Jordan School District Riverton Elementary School Remodel

GSBS Project No. 2023.043.00

ADDENDUM NO. 1

February 13, 2024

P1 - GREEN PORTAL

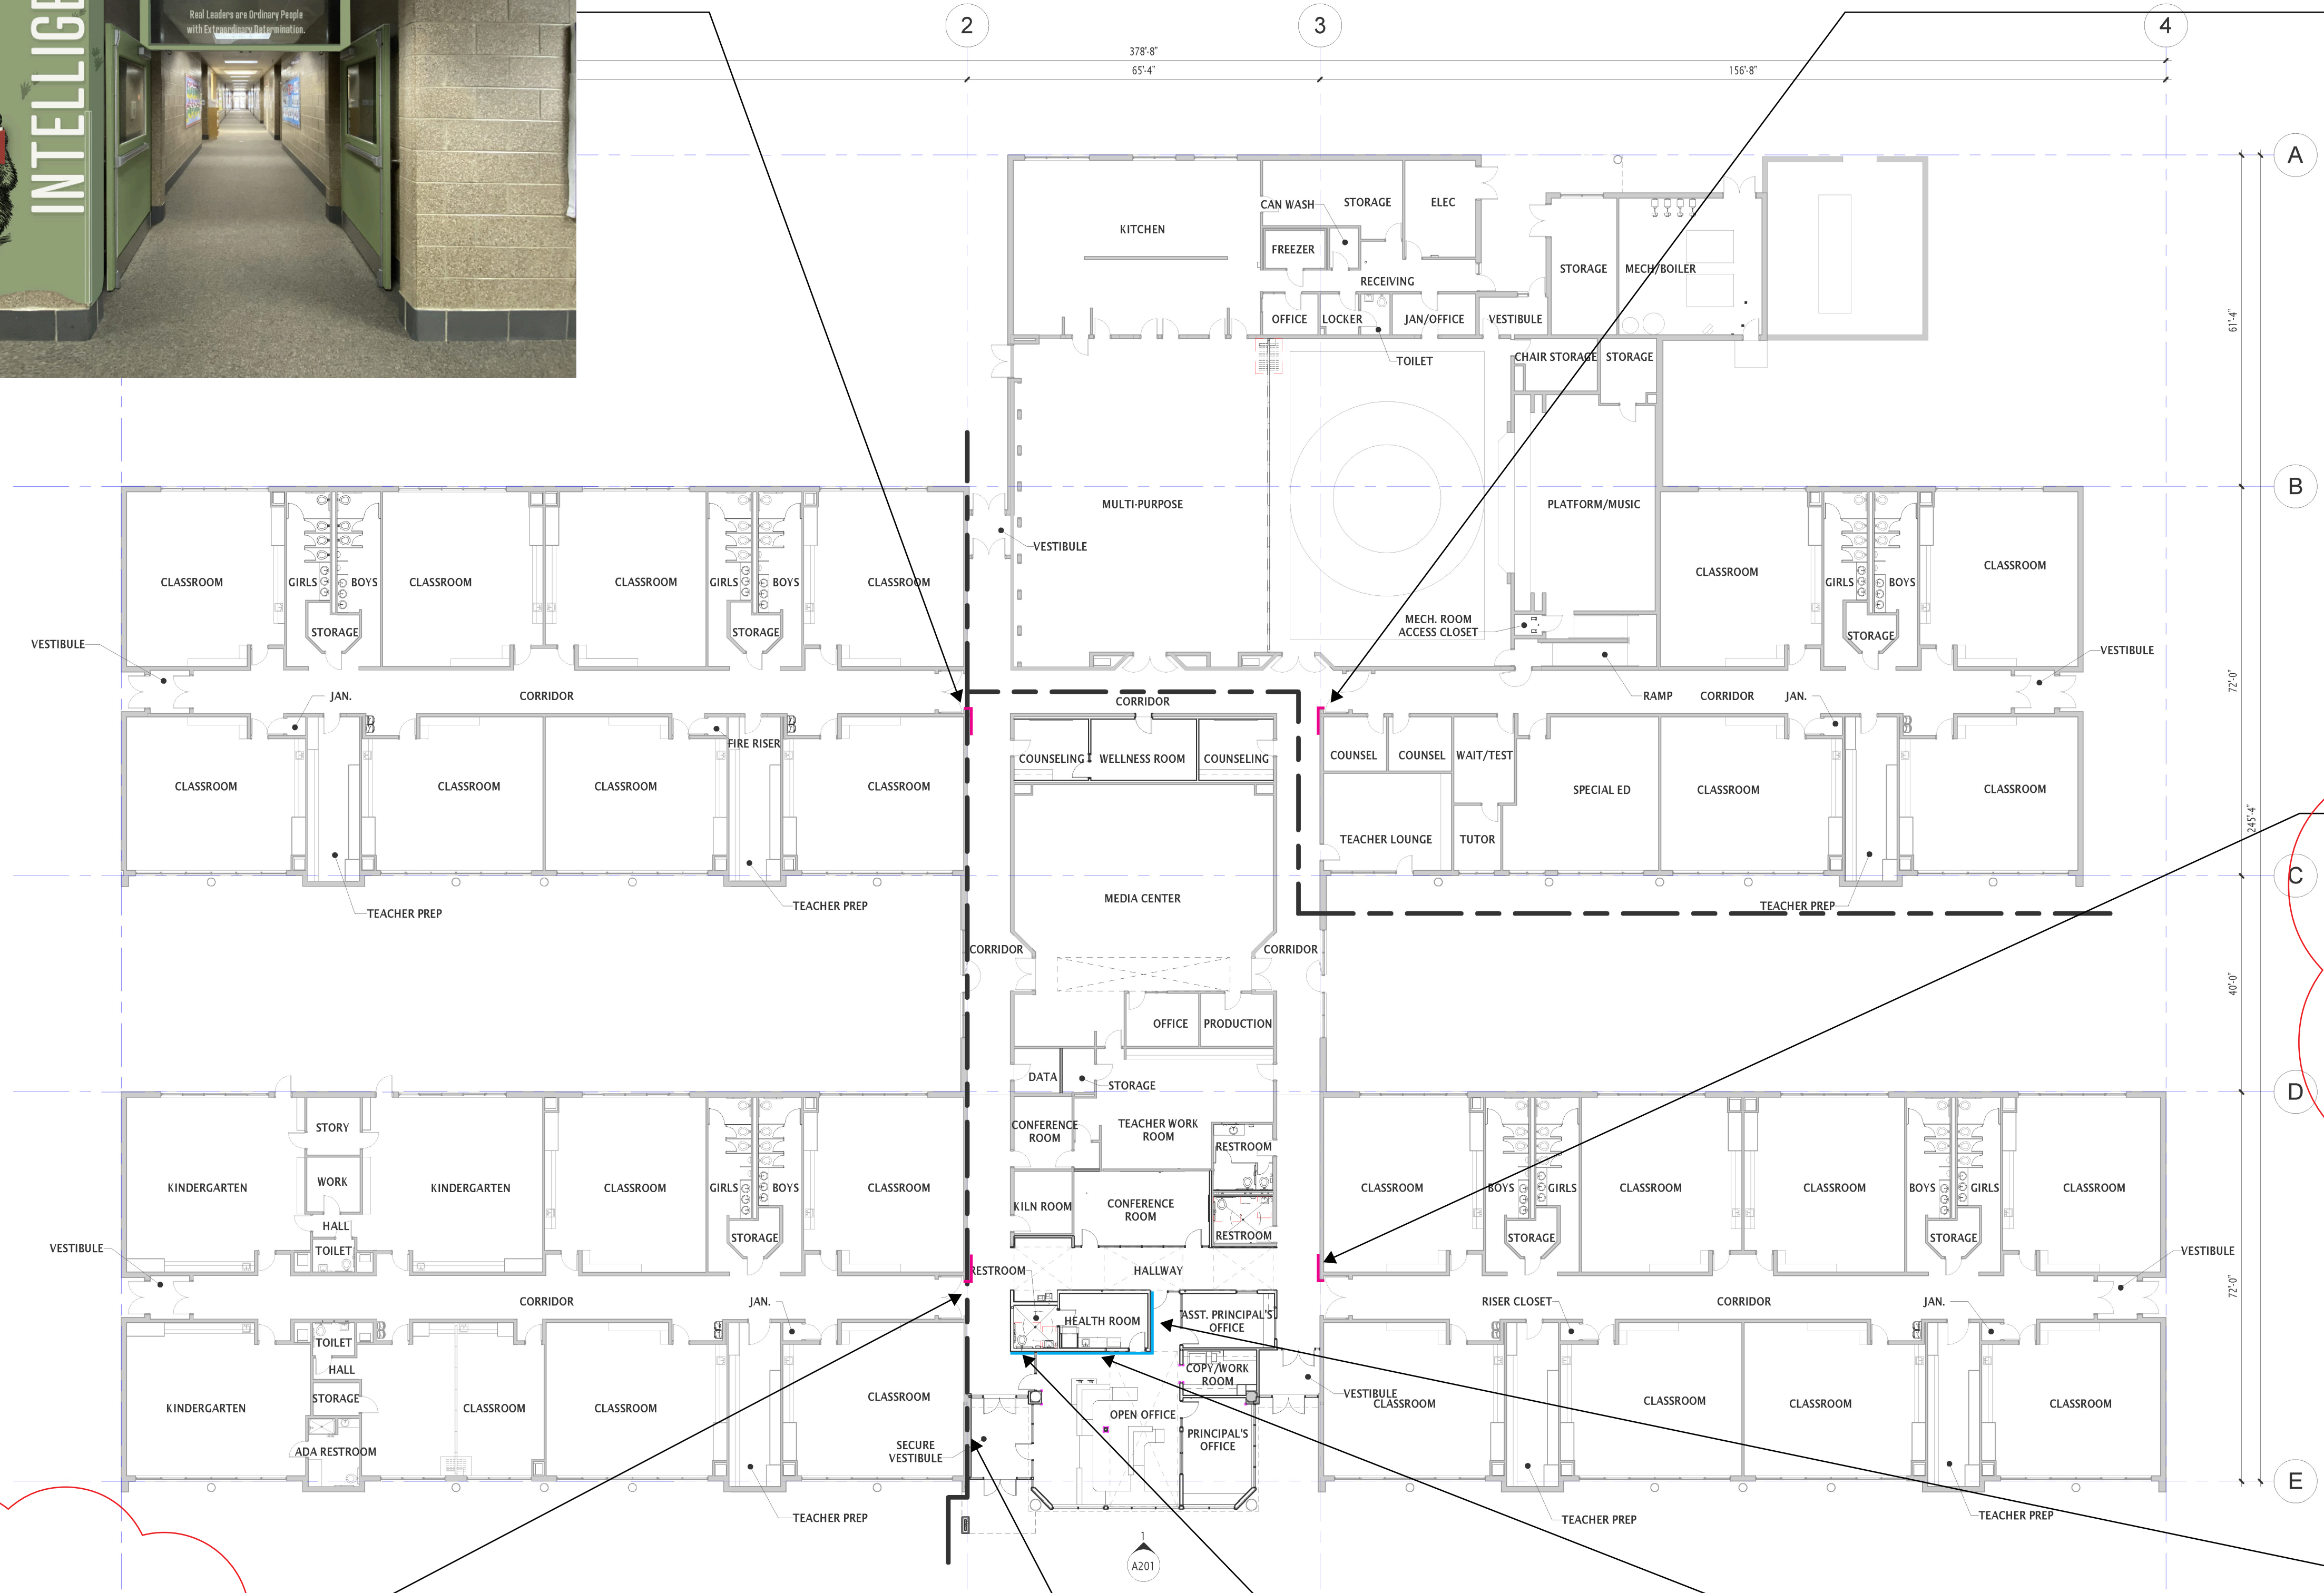
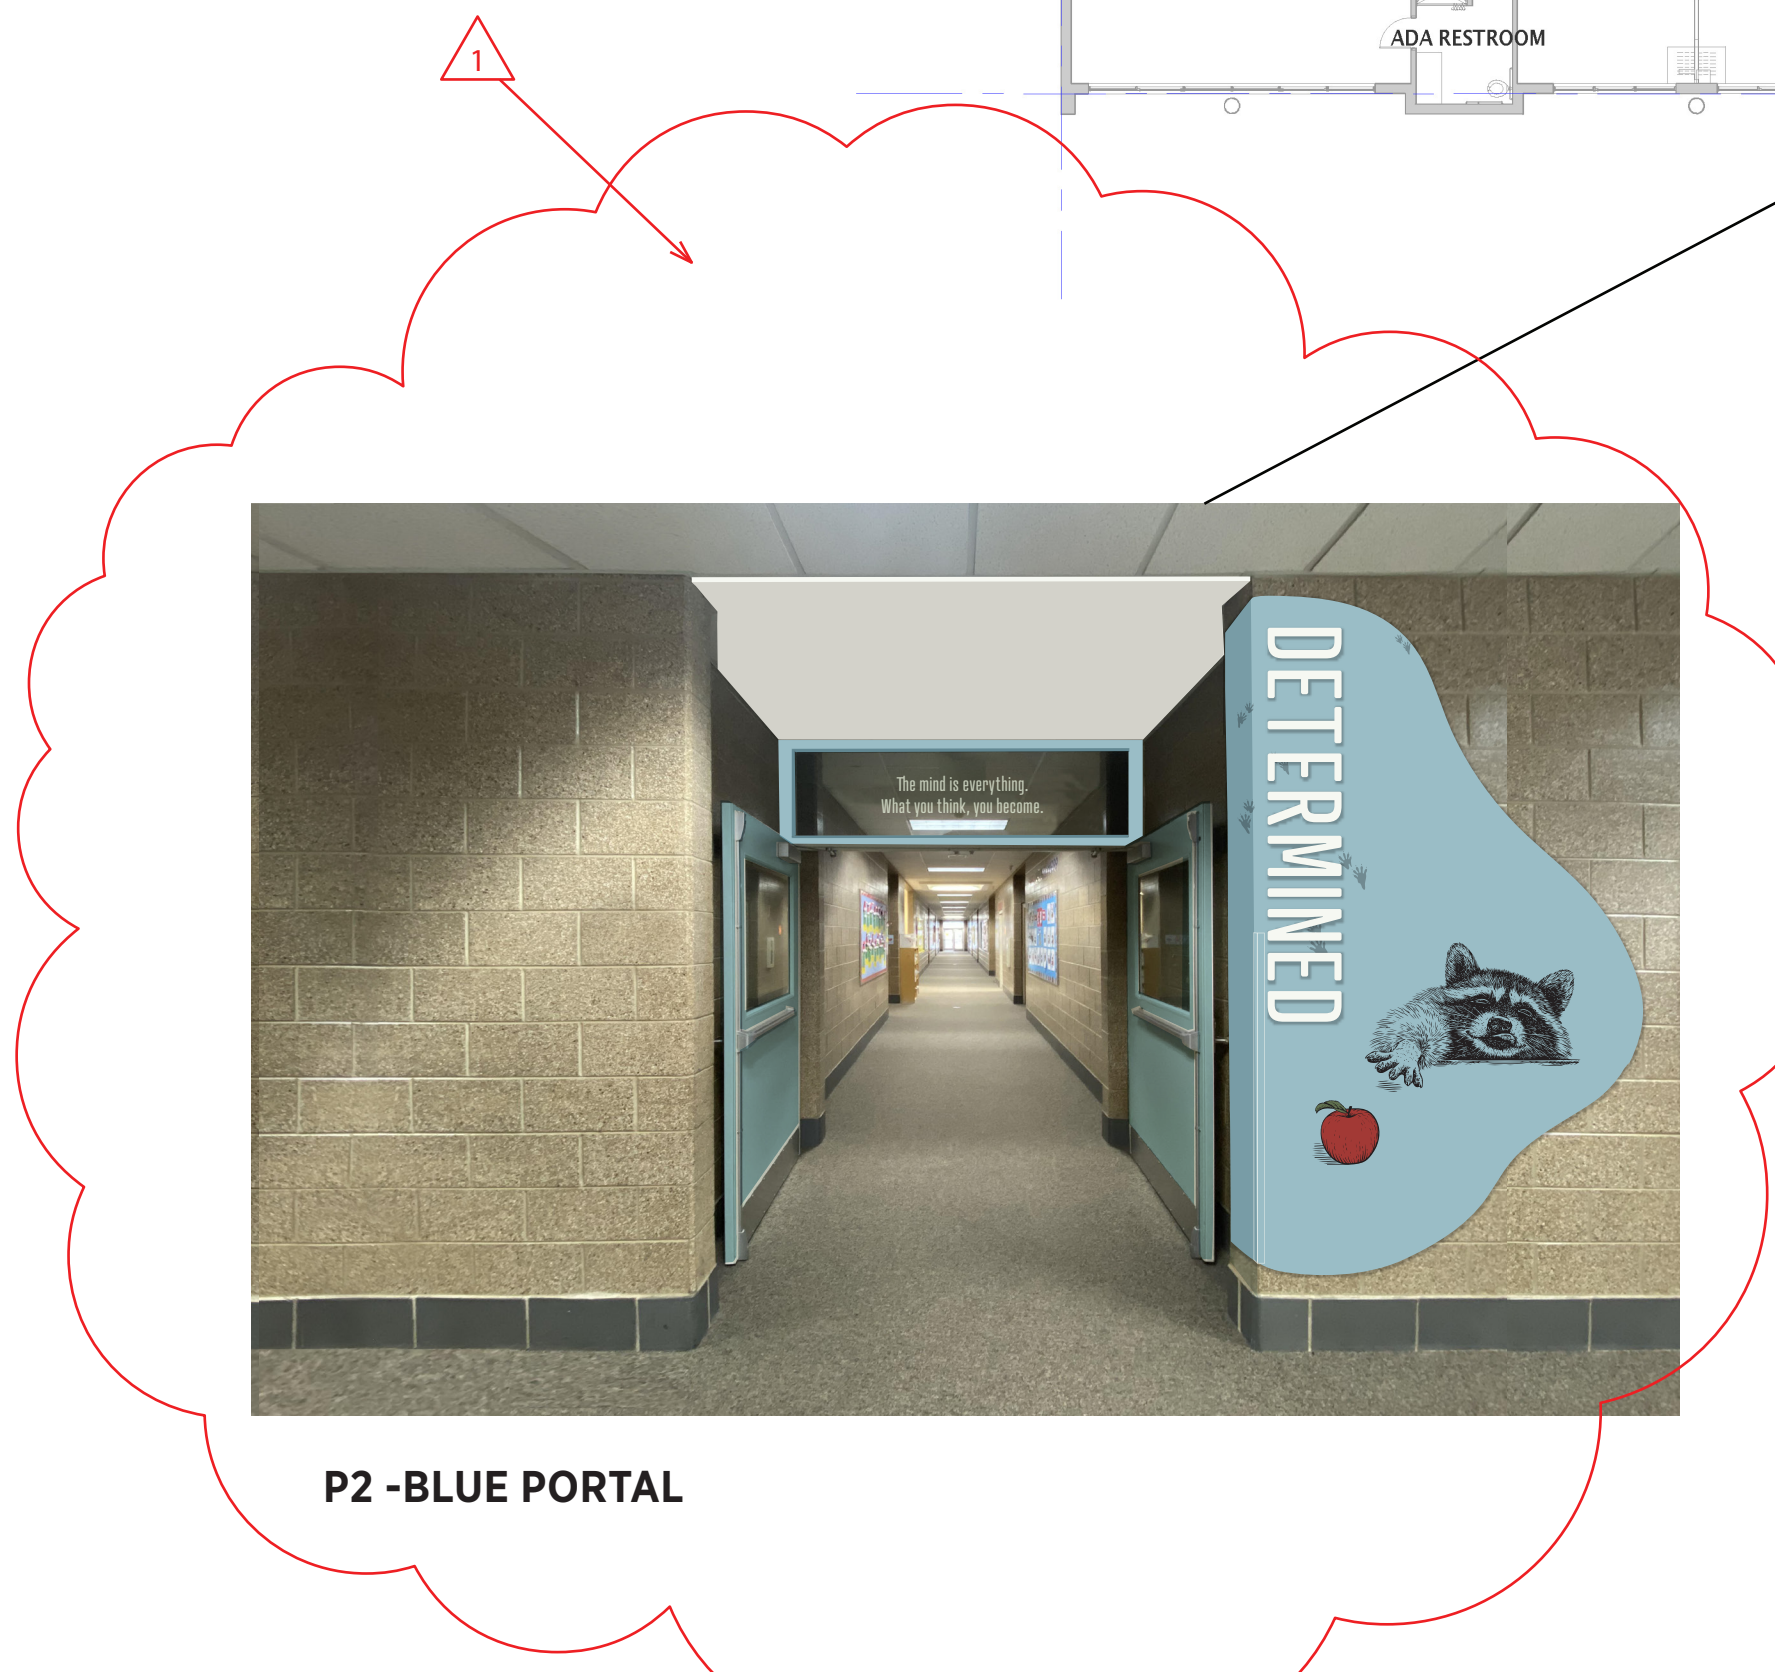
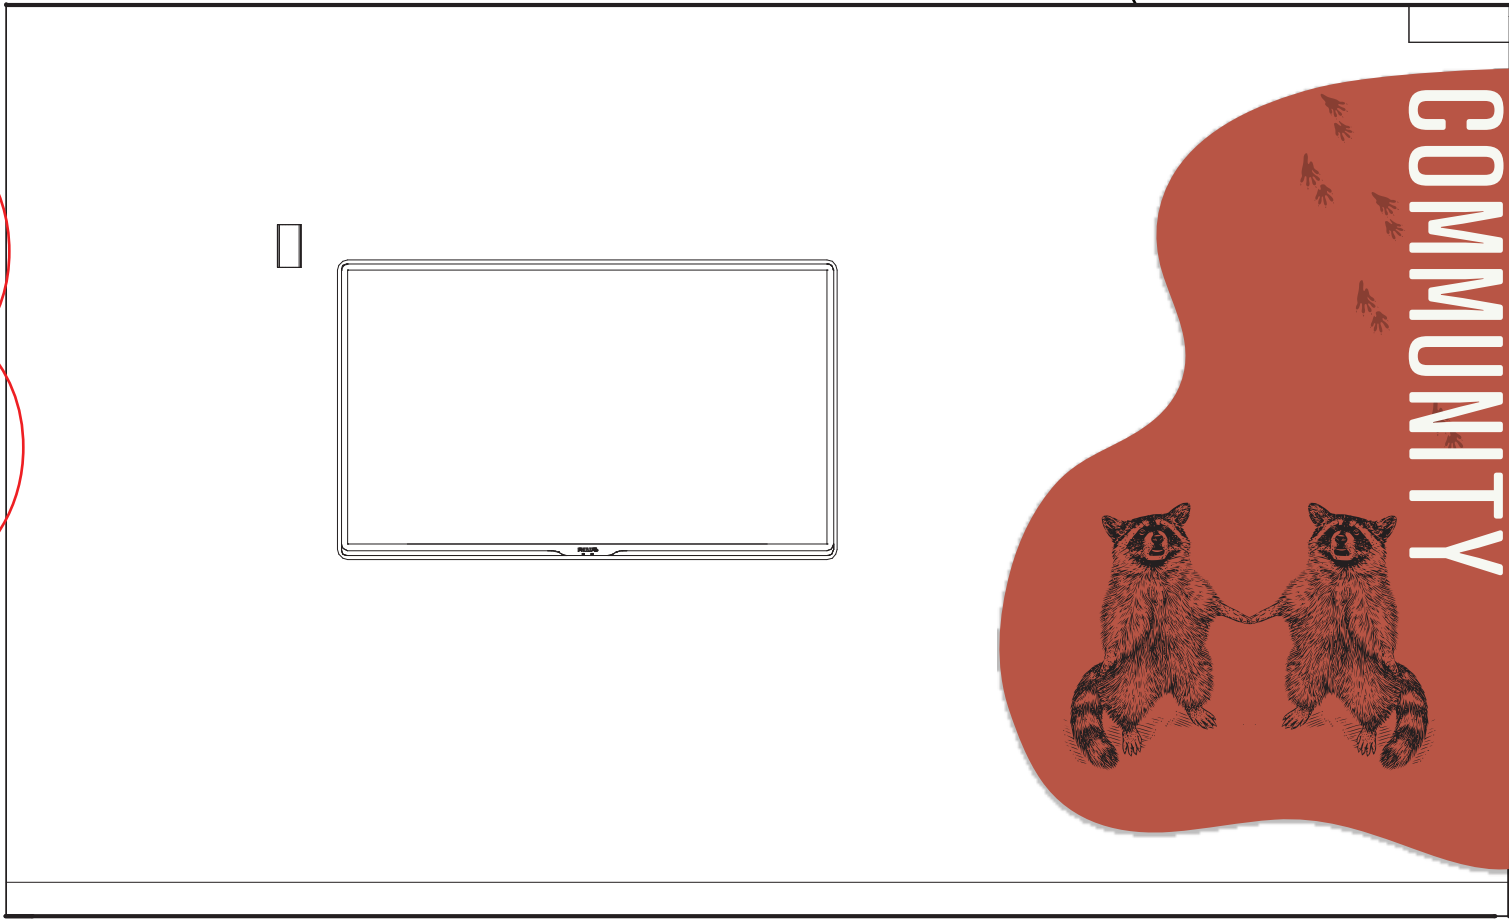
1. Added note to material P4, Comments section.

Article 2.3 - Interior Wayfinding Portal Frames and Jambs for Opaque Finish, add the following: " (Indicated on Drawings as P1, P2, P3, P4, P5)."
